Product Change Notification

LFPCN#: 41289

T-Line TSM600 series housing design change

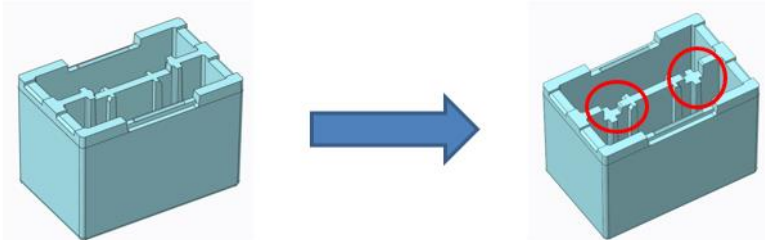
Current design assembly process could create burrs at the bottom of TSM600-250F devices which can cause device to be raised off surface and lead to loose solder joints. As a preventative measure, the housing design was re-evaluated. This is a minor cosmetic change that will not affect performance.

1. **Part appearance will be changed due to minor cosmetic change on bottom of housing.**
